**Additions and Renovations
Platt Technical High School
Milford, CT**

ADDENDUM NO. 5

August 15, 2019

SECOND FLOOR AND LOW ROOF FRAMING PLAN - AREA E
SCALE: 1/8" = 1'-0"

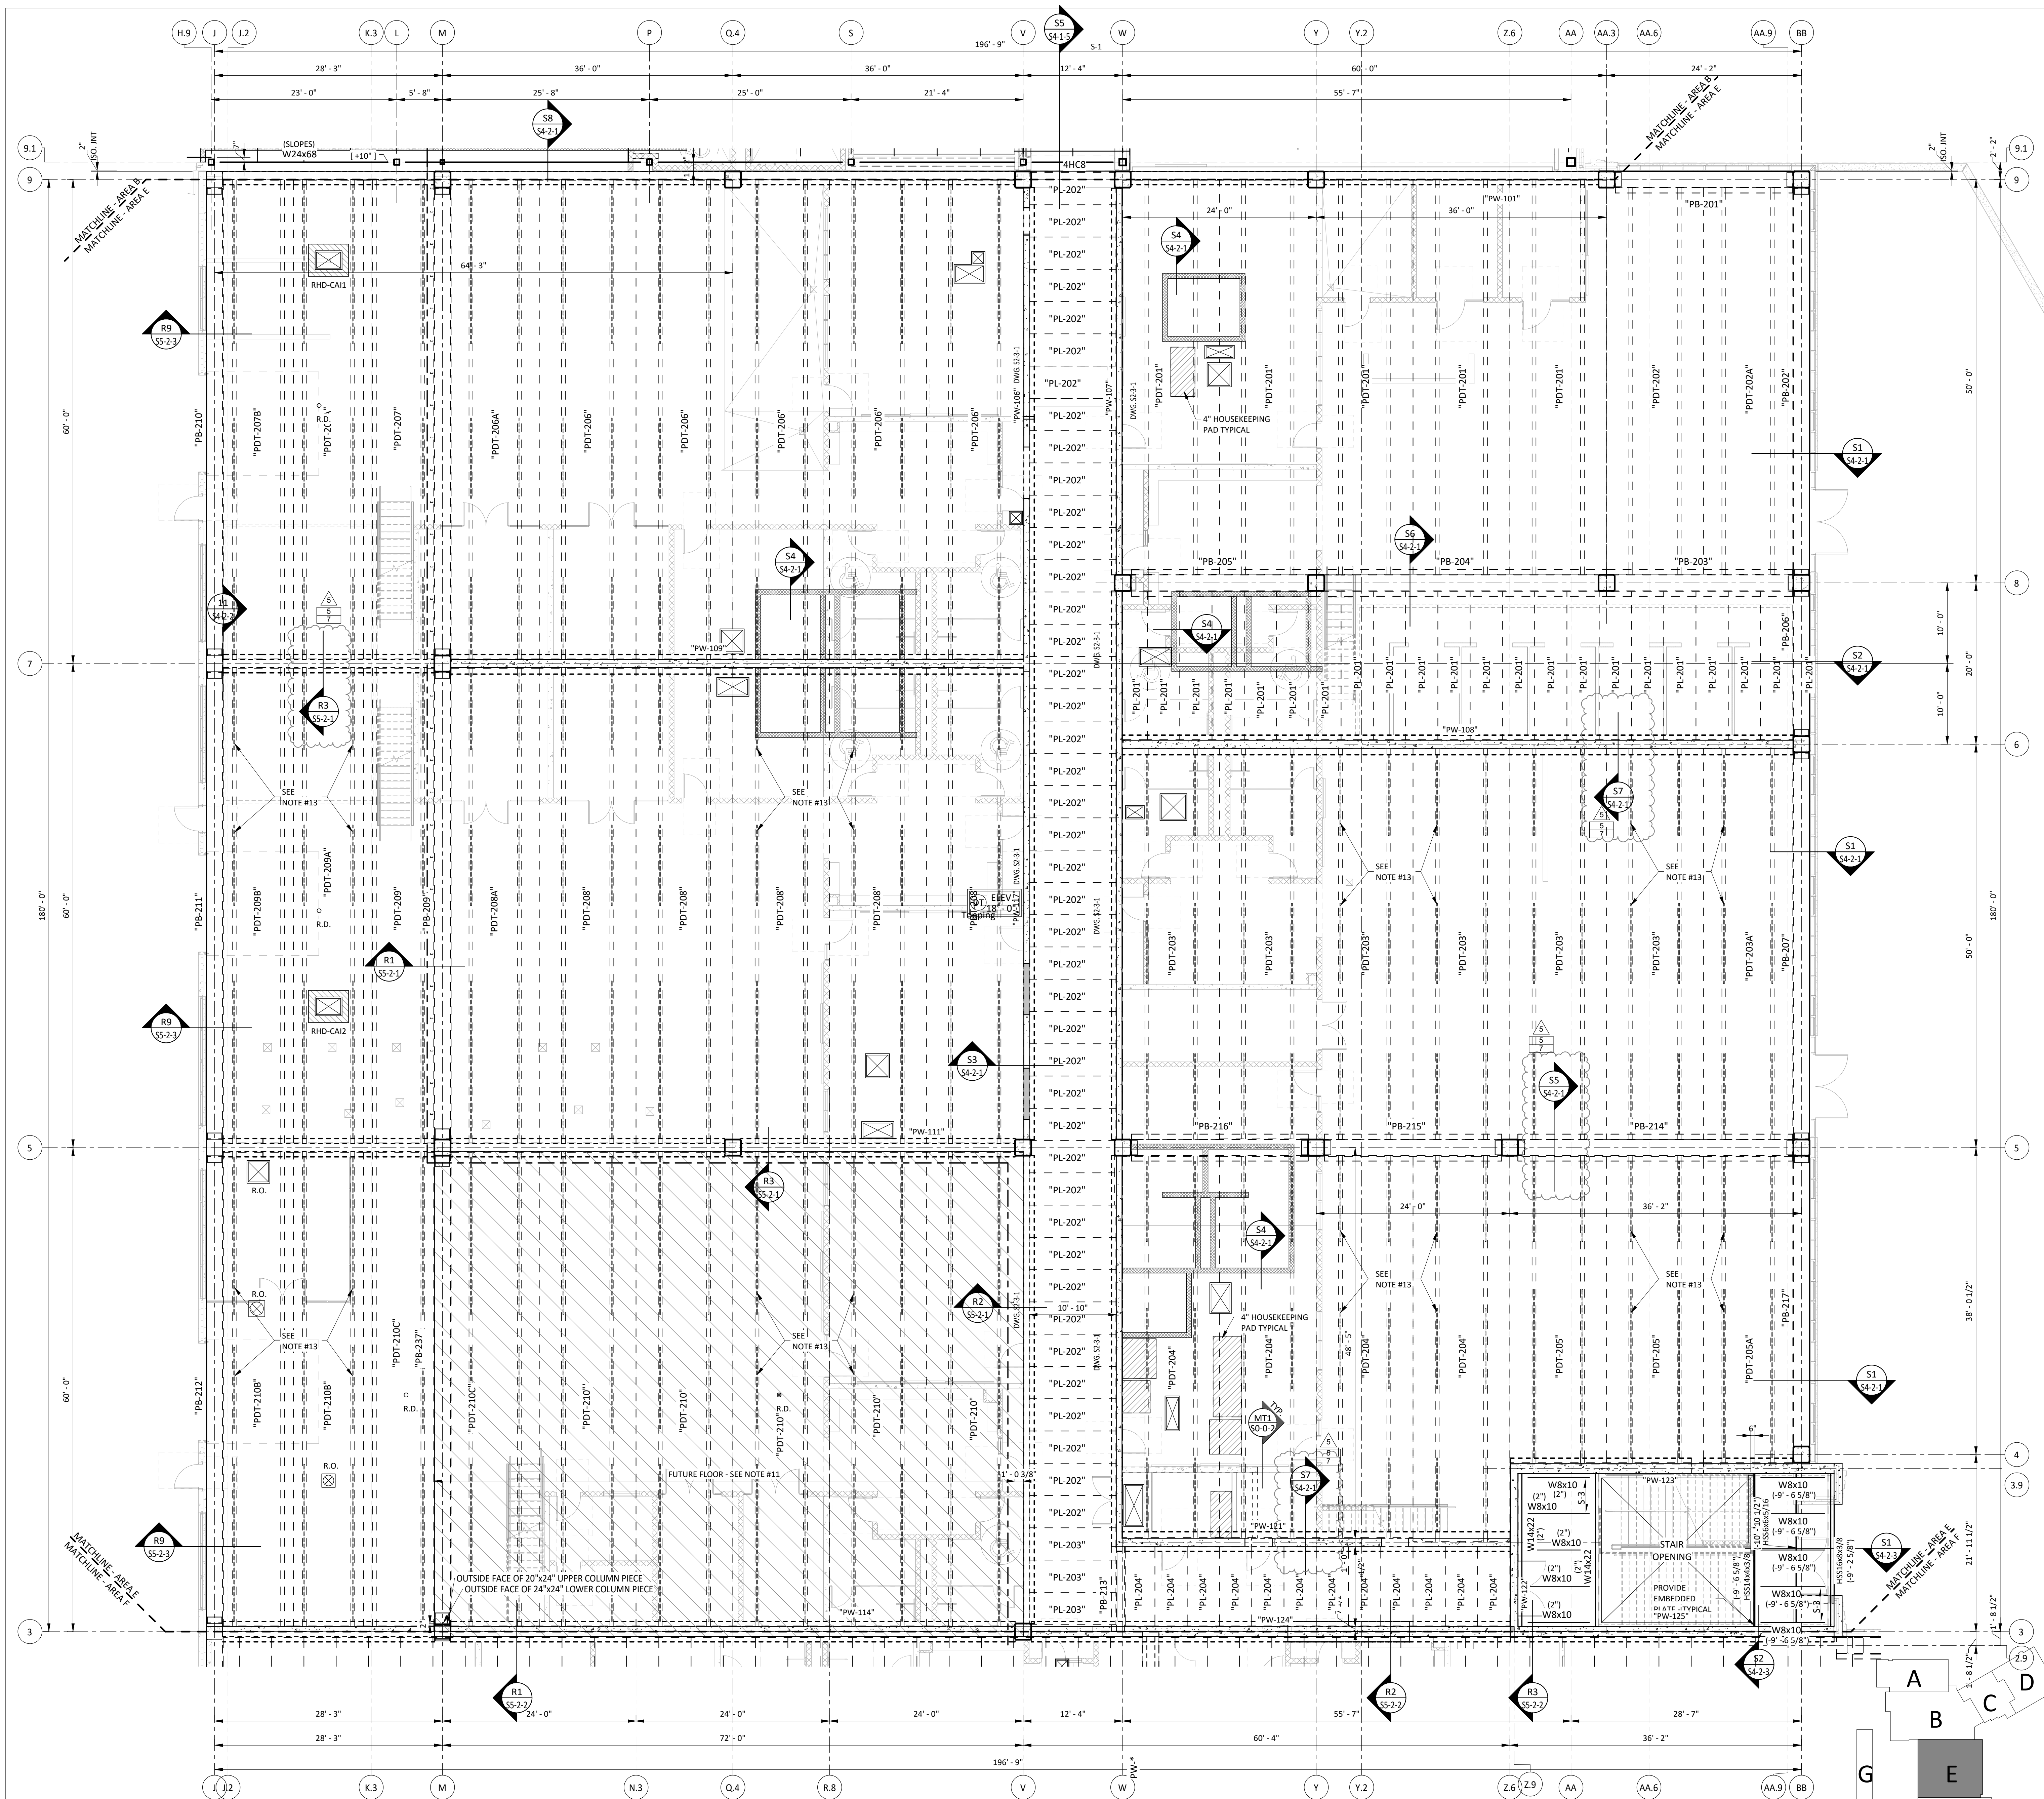
- ADD 5-039 DRAWING S1-1-2A – SECOND FLOOR FRAMING PLAN – AREA A**
ADD bleacher restraint framing – refer to Sketch RS5-006.
- ADD 5-040 DRAWING S1-1-2E – SECOND FLOOR AND ROOF FRAMING PLAN – AREA E**
On the Second Floor and Roof Framing Plan Notes:
Note 1, CHANGE the top of concrete slab elevation FROM 118’-0” TO 117’-0”
For Note 2, CHANGE the top of precast elevation FROM 117’-8” TO 116’-8”

- ADD 5-041 DRAWING S1-1-2E – SECOND FLOOR AND LOW ROOF FRAMING PLAN – AREA E**
ADD section designations per Revision RS5-7.
REVISE plan notes #1 and #2 per Revision RS5-8.
ADD plan notes #14 and #15 per Revision RS5-9.

ROOF FRAMING PLAN - AREA E

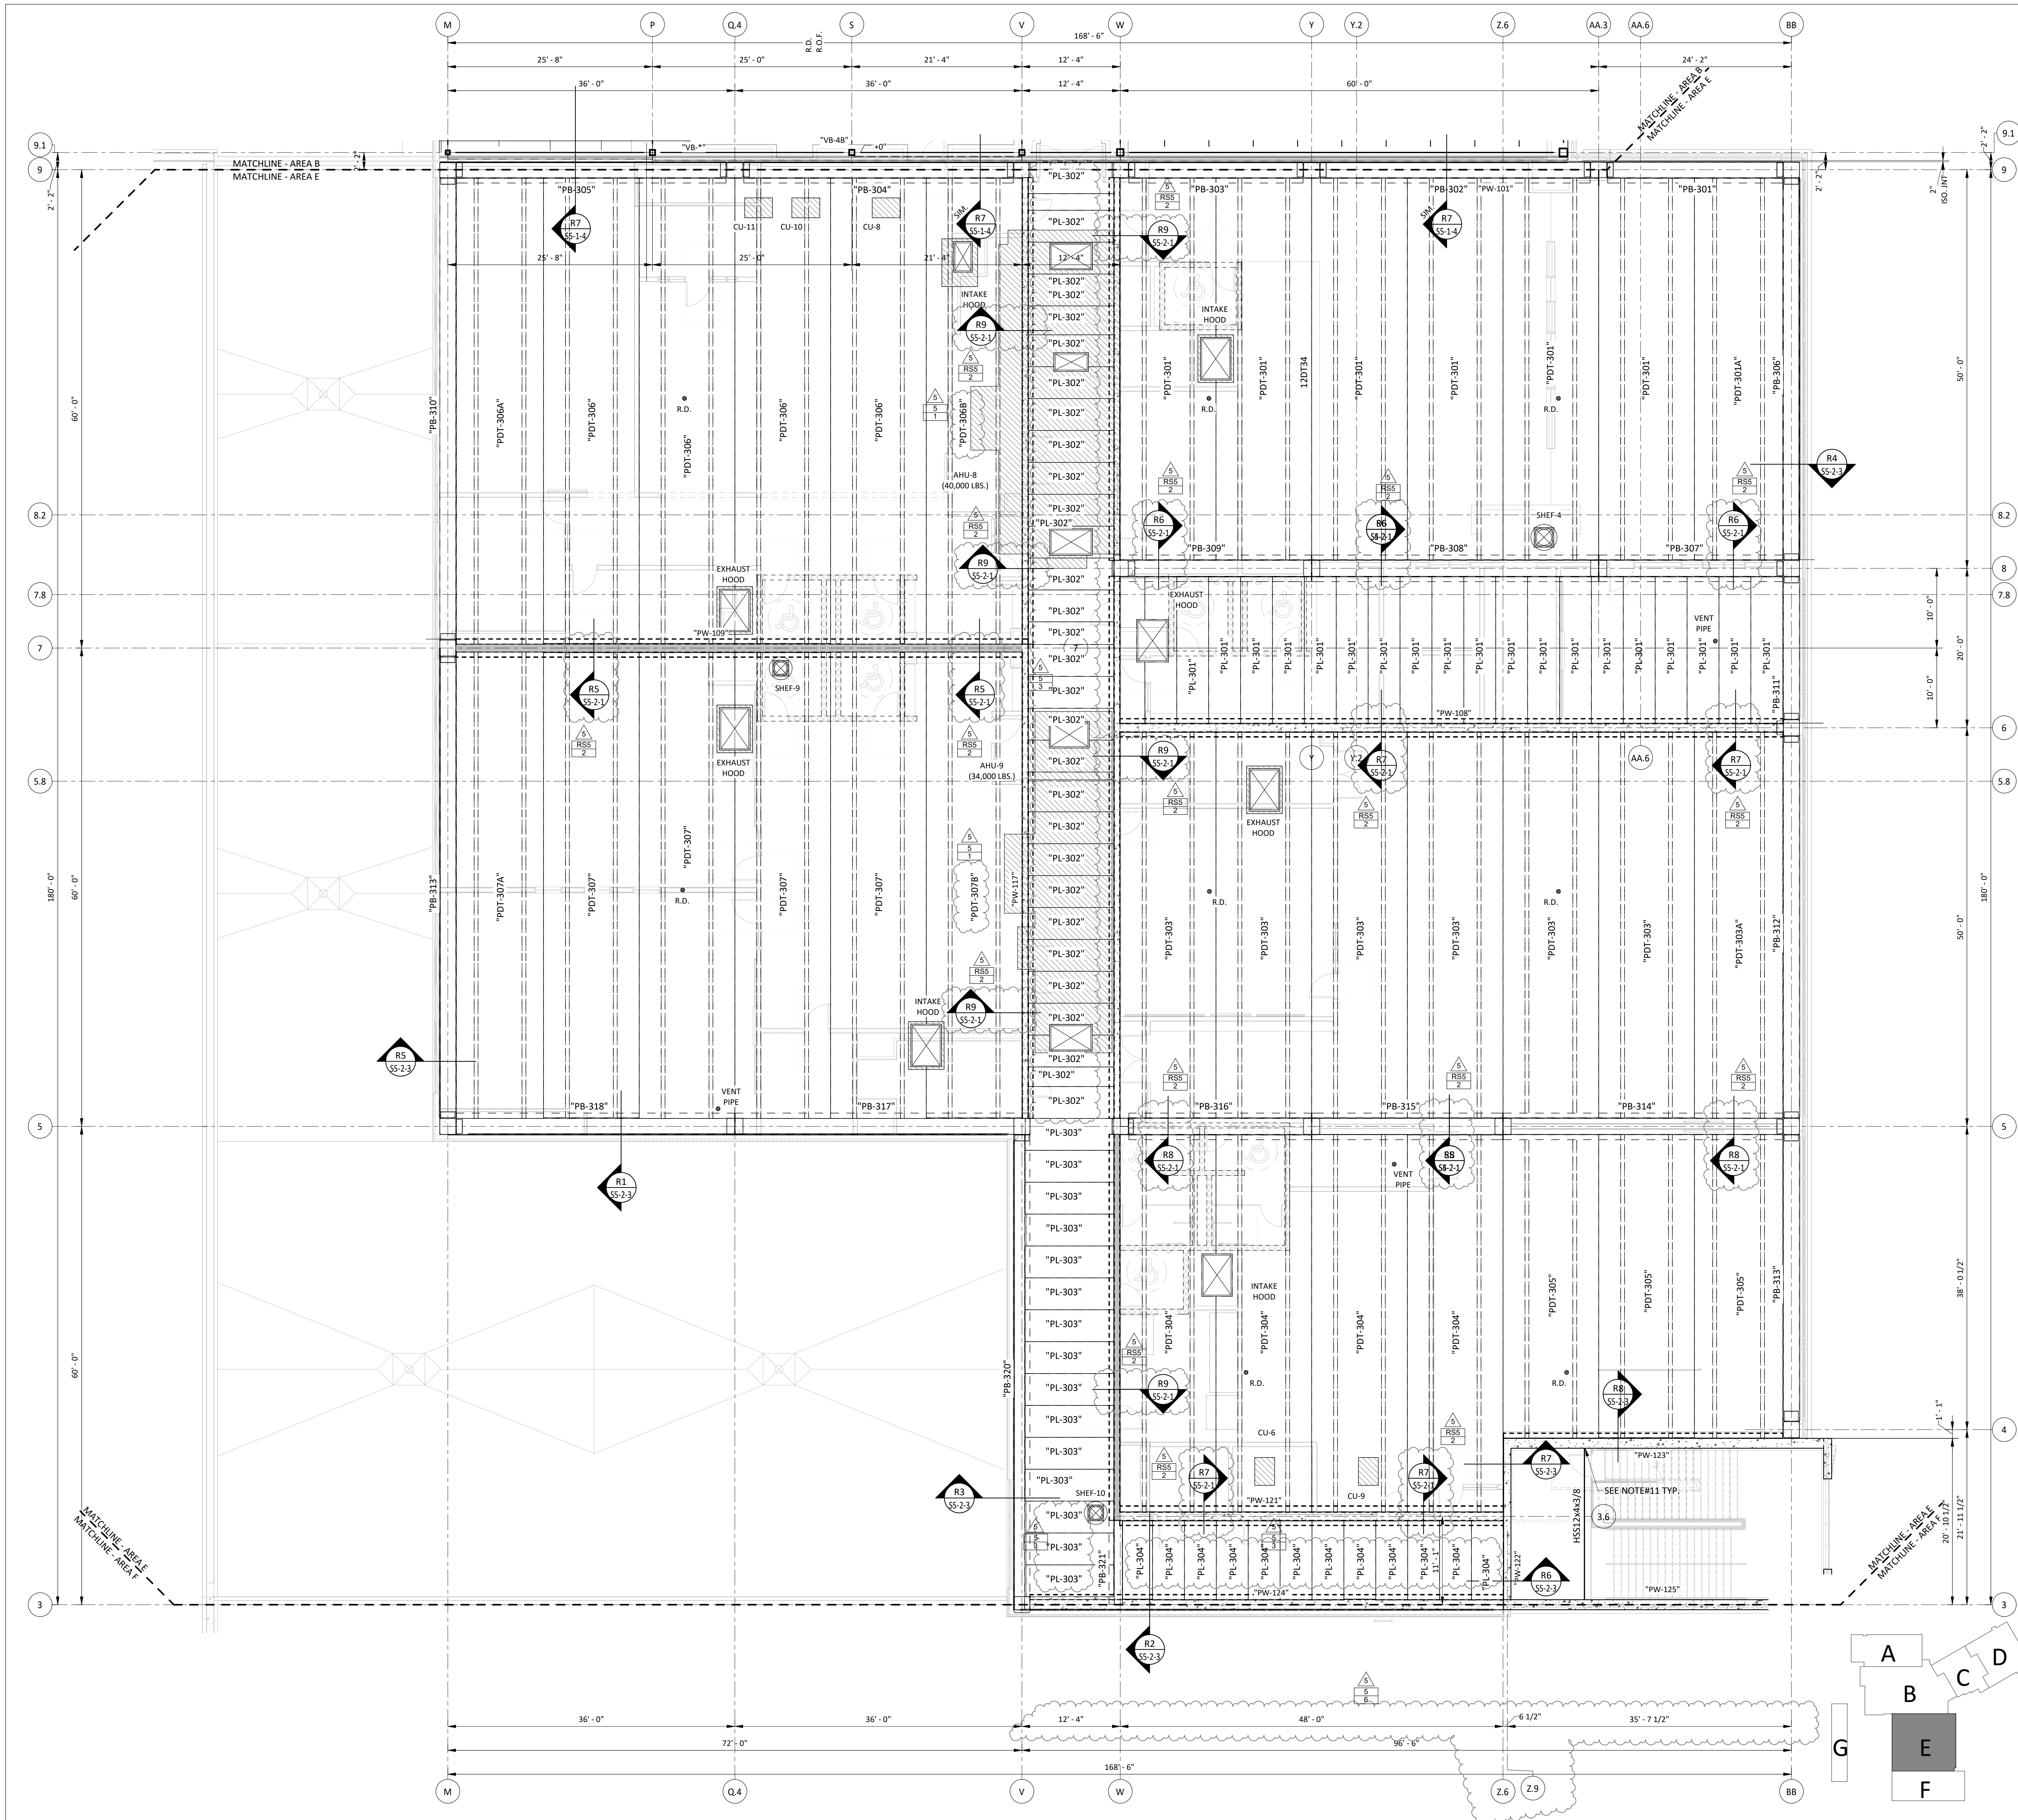
- ADD 5-042 DRAWING S1-1-3E – ROOF FRAMING PLAN – AREA E**
 REVISE two designations per Revision RS5-1.
 ADD section designations per Revision RS5-2.
 REVISE plank designations per Revision RS5-3.
 REVISE plan notes #1 and #2 per Revision RS5-4.
 ADD plan notes #10 and #11 per Revision RS5-5.
 REVISE dimensions per Revision RS5-6.

- ADD 5-043 DRAWING S1-1-3E – ROOF FRAMING PLAN – AREA E**
 On the Roof Framing Plan Notes:
 Note 1, CHANGE the top of concrete slab elevation FROM 132'-3" TO 131'-3"
 For Note 2, CHANGE the top of precast elevation FROM 131'-11" TO 130'-11"

MEZZANINE FRAMING PLAN - AREA E
SCALE: 1/8" = 1'-0"

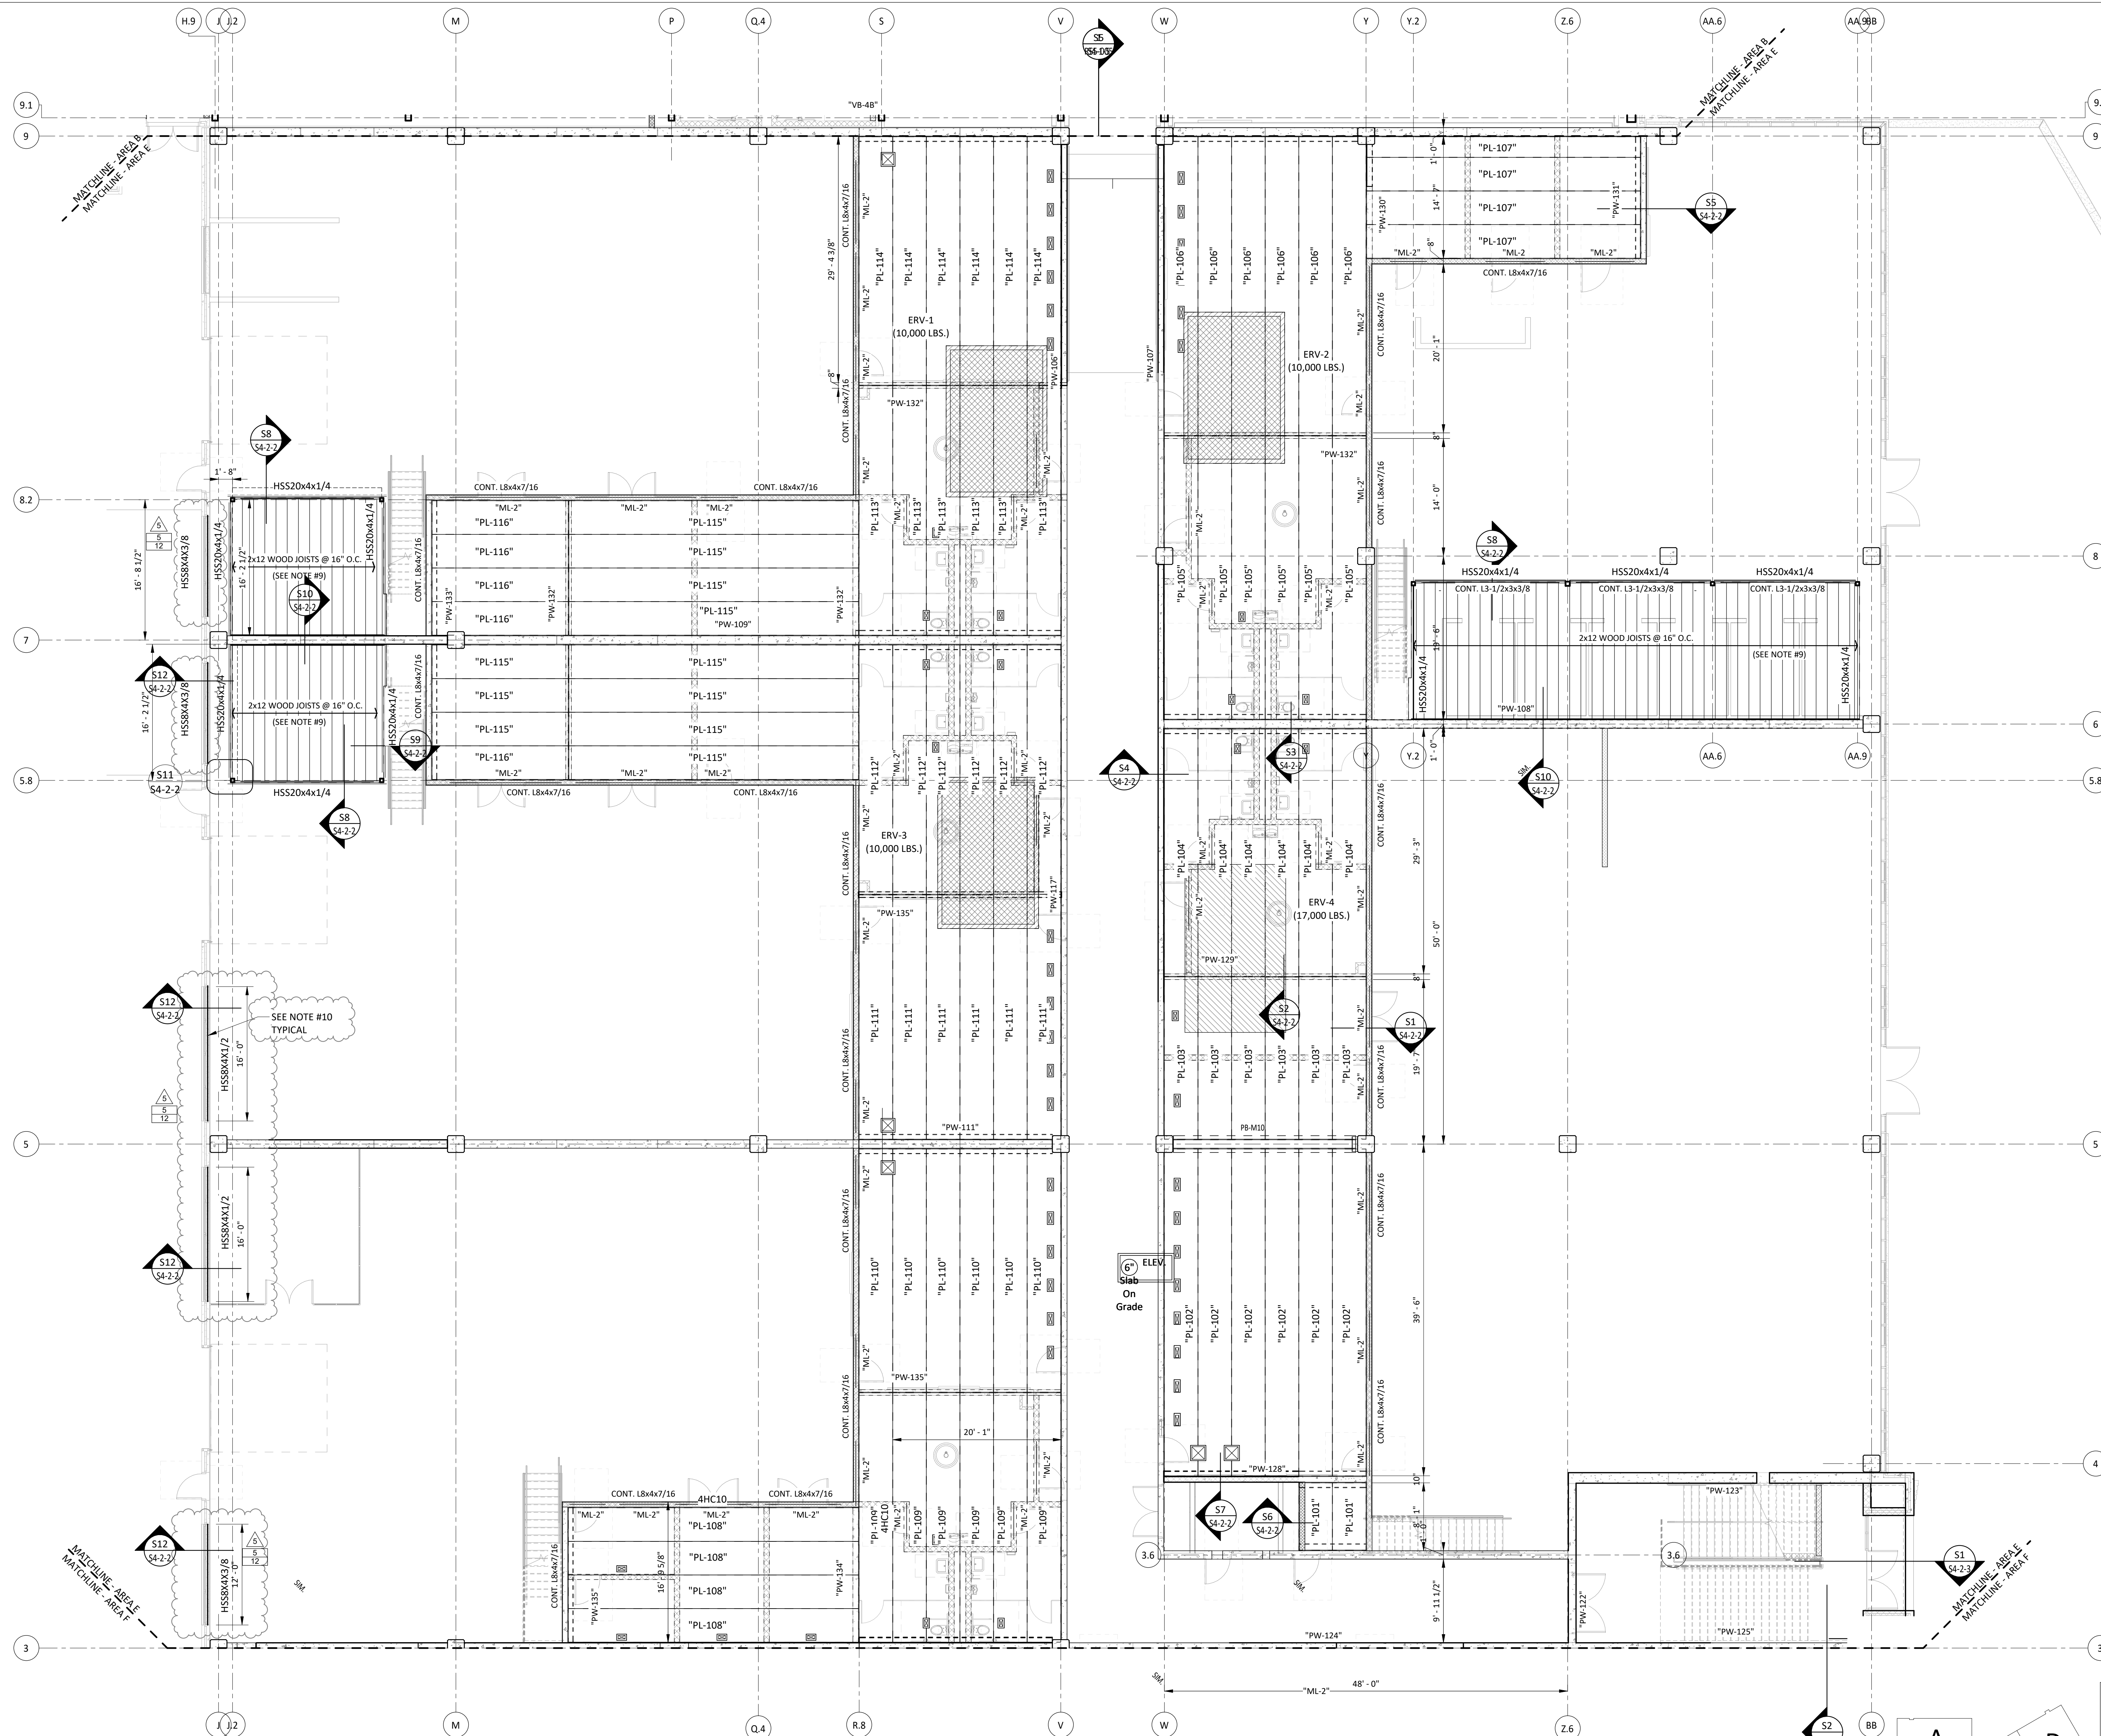
- ADD 5-044 DRAWING S1-1-3F – ROOF FRAMING PLAN – AREA F**
 Plan notes are revised – refer to Sketch RS5-001.
- ADD 5-045 DRAWING S1-1-ME – MEZZANINE FRAMING PLAN – AREA E**
 ADD wall girts per Revision 12.
